Access Compliance Report

Public Rights-of-Way

(Curb Ramps)

Intersection ID: 10025077	Main Street: DOVE_MEADOW_DR	Cross Street: N/A	Location: NE
ADA ID: 052946376BF9	Ramp Type: Perp	Initial Pass/Fail: Fail	Overall Compliance: No
Codes/Mitigation Info/Possible Solution		Field Measurements/Component Compliance

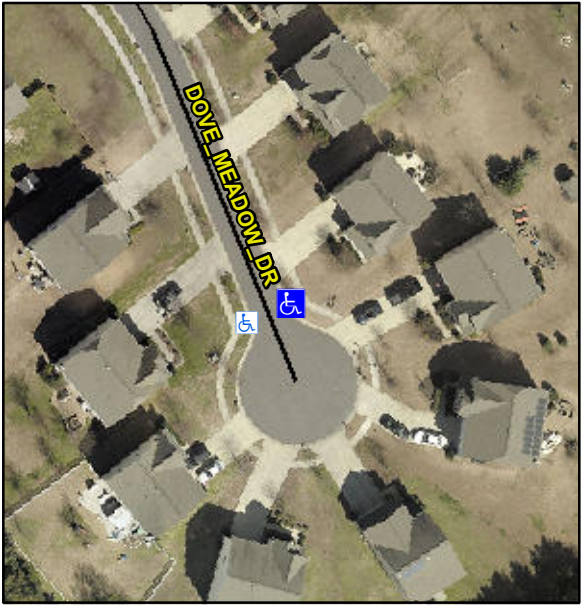
Possible Solutions:						
	Remove & Replace Entire Ramp.	N/A	Ramp Length (in)	72.0	Yes	Ramp Slope (%)	5.8
		No	Ramp Width (in)	47.0	No	Ramp XSlope (%)	3.1
		N/A	Flare Type LT	N/A	N/A	Flare Type RT	N/A
		N/A	Flare Slope LT (%)	N/A	N/A	Flare Slope RT (%)	N/A
		N/A	Flare Traversable LT?	N/A	N/A	Flare Traversable RT?	N/A
		N/A	Landing Length (in)	N/A	N/A	DWS Provided?	N/A
		N/A	Landing Width (in)	N/A	N/A	DWS Contrast?	N/A
		N/A	Landing Slope (%)	N/A	N/A	DWS Length (in)	N/A
		N/A	Landing X Slope (%)	N/A	N/A	DWS Full Width?	N/A
		N/A	Landing Curb? (Y/N)	N/A	N/A	DWS Offset (in)	N/A
		N/A	Shared Landing?	N/A			
		N/A	Gutter Ponding?	N/A	N/A	Gutter Slope (%)	N/A
		N/A	Gutter Lip Ht (in)	N/A	N/A	Gutter X Slope (%)	N/A
		N/A	Painted X Walk1?	No	N/A	Painted X Walk2?	N/A
			X Walk 1 Direction	To SW		X Walk 2 Direction	N/A
		N/A	X Walk 1 Width (in)	N/A	N/A	X Walk 2 Width (in)	N/A
			X Walk 1 Slope (%)	3.7		X Walk 2 Slope (%)	N/A

X Walk 1 X Slope (%)	0.8		X Walk 2 X Slope (%)	N/A
		N/A	Ramp inside XWalk1?	N/A	N/A	Ramp inside XWalk2?	N/A
<p>Surveyor Notes:</p> <p>N/A</p>			Road Slope (%)	N/A	N/A	Clear Space?	N/A
			Road X Slope (%)	N/A	N/A	Clear Space to XWalk (in)	N/A
<p>PROW/ADA:</p> <p>R304.5.1, R304.5.3</p>		N/A	Any Obstructions?	N/A	N/A	Storm Grate/Utility Hazard?	N/A
			Obstruction Type			Storm Grate/Utility Type	
Total Cost:		\$	1850.00		N/A		N/A
					Yes	Surface Condition? (G/P)	Good
